Product Change Notification

10512887

Changing selected Mini-Fit® and KK® Product that were Overall Gold Plated Terminals to Select Gold, or Gold only in the contact area, and Matte Tin in solder tail area (changing solder tails from Overall Gold Plating to Matte Tin Plating)

Product Image:

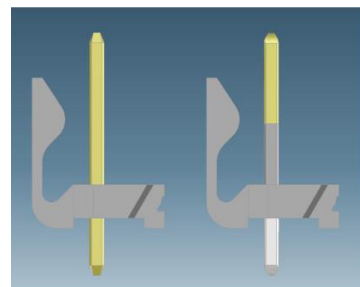
Overall Gold plating removed from solder tail area only and replaced with Matte Tin plating
Contact area to have same amount of Gold Plating; no changes to the contact area

Part numbers to remain the same; this will be a running change

This change will remove gold plating from the solder tail area but plating will remain the same in the contact area. This will be a running change, so the part numbers will remain the same and parts shipped after Nov 1st, 2011 will transition to the select gold plating in the contact area and matte tin in the tail area. All product shipping through Oct. 31st, 2011 will continue to have overall gold on the header pin. Beginning November 1st, 2011, all parts on the attached list will transition to gold plating in the contact area and matte tin in the solder tail area.
